**PCN-2014-548**

**Assembly and Test Site Transfer from StatsChipPac Kuala Lumpur, Malaysia (SCM) to ASE-Chung Li (ASE-CL) Taiwan for the CS42L56-CNZ(R) component**

**Process/Product Change Notification  
(Reference Advance PCN-2014-533)**

**Date:** July 2014

**Below you will find a representative example:**

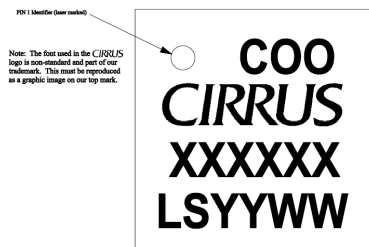
Mark change:

- Assembly vendor = None (not shown on mark)
- COO = changing From: **MAL** → TO: **TWN**

Line 1: Country Of Origin (COO)

Line 2: Logo Line.

Line 3: Part Number (6 spaces max.)

Line 4: Package Mark (6 spaces max.)

With the Assembly Site and Test Transfer to ASE-Chung Li (ASE-CL) Taiwan, the material will receive the appropriate designation for the Country Of Origin.
